Access Compliance Report

Public Rights-of-Way

Intersection ID: 31473	Main Street: ALSTON_HILL_DR	Cross Street: EMERALD_FERN_WY	Location: NE
ADA ID: 7D66F13FD7E7	Ramp Type: BlendTrans1	Initial Pass/Fail: Fail	Overall Compliance: No
		Severity Score: 25

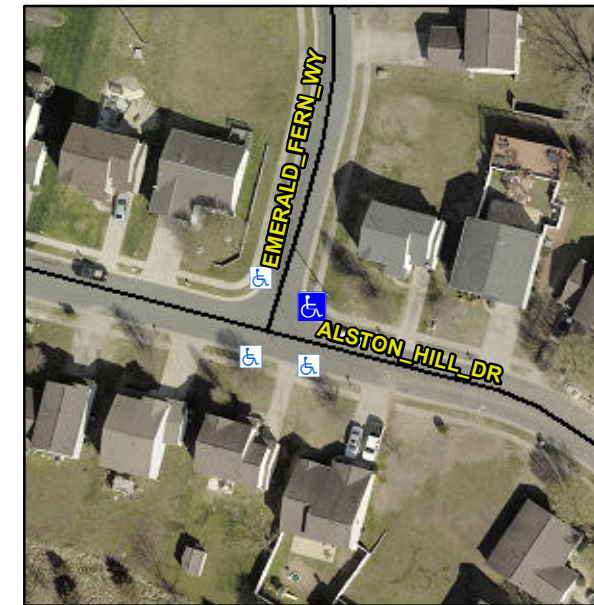
Not Found, R304.5.3

Compliance	Description	Data	Compliance	Description	Data
N/A	Ramp Length (in)	48.0	Yes	BlendTrans Slope (%)	4.7
Yes	Ramp Width (in)	48.5	No	BlendTrans XSlope (%)	7.5
N/A	Flare Type LT	N/A	N/A	Flare Type RT	N/A
N/A	Flare Slope LT (%)	N/A	N/A	Flare Slope RT (%)	N/A
N/A	Flare Traversable LT?	N/A	N/A	Flare Traversable RT?	N/A
N/A	Landing Length (in)	N/A	N/A	DWS Provided?	N/A
N/A	Landing Width (in)	N/A	N/A	DWS Contrast?	N/A
N/A	Landing Slope (%)	N/A	N/A	DWS Length (in)	N/A
N/A	Landing X Slope (%)	N/A	N/A	DWS Full Width?	N/A
N/A	Landing Curb? (Y/N)	N/A	N/A	DWS Offset (in)	N/A
N/A	Shared Landing?	N/A			
N/A	Gutter Ponding?	N/A	N/A	Gutter Slope (%)	N/A
N/A	Gutter Lip Ht (in)	N/A	N/A	Gutter X Slope (%)	N/A
N/A	Painted X Walk1?	No	N/A	Painted X Walk2?	No
	X Walk 1 Direction	To W		X Walk 2 Direction	To S
	X Walk 1 Width (in)	N/A		X Walk 2 Width (in)	N/A
	X Walk 1 Slope (%)	1.8		X Walk 2 Slope (%)	4.0
	X Walk 1 X Slope (%)	4.8		X Walk 2 X Slope (%)	4.0

Remove & Replace Curb Ramp With Two New Directional Ramps or Equivalent.
